Product/Process Change Notice (PCN)

PCN_WE_CMBNiZn_744841_20150403_Spacer.doc

Product Affected: WE-CMBNiZn Size XS Series

New part

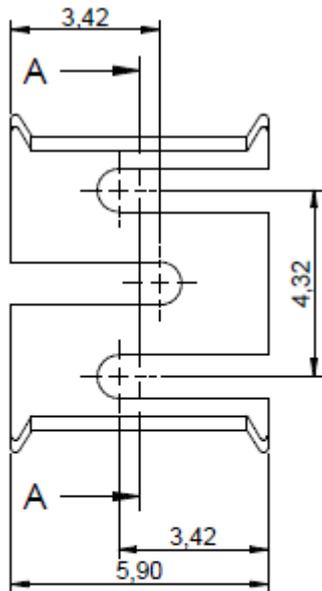
The plastic raw material has been changed from FR4 to Ultramid A3X2G5. The new spacer is mechanical fixed by the design therefore no additional glue joint is needed. We also increased the spacer thickness from 2,5 mm to 3,0 mm. Electrical and mechanical specifications will not be affected. Further the new spacer material is RoHS, REACH compliant and free of Halogen.
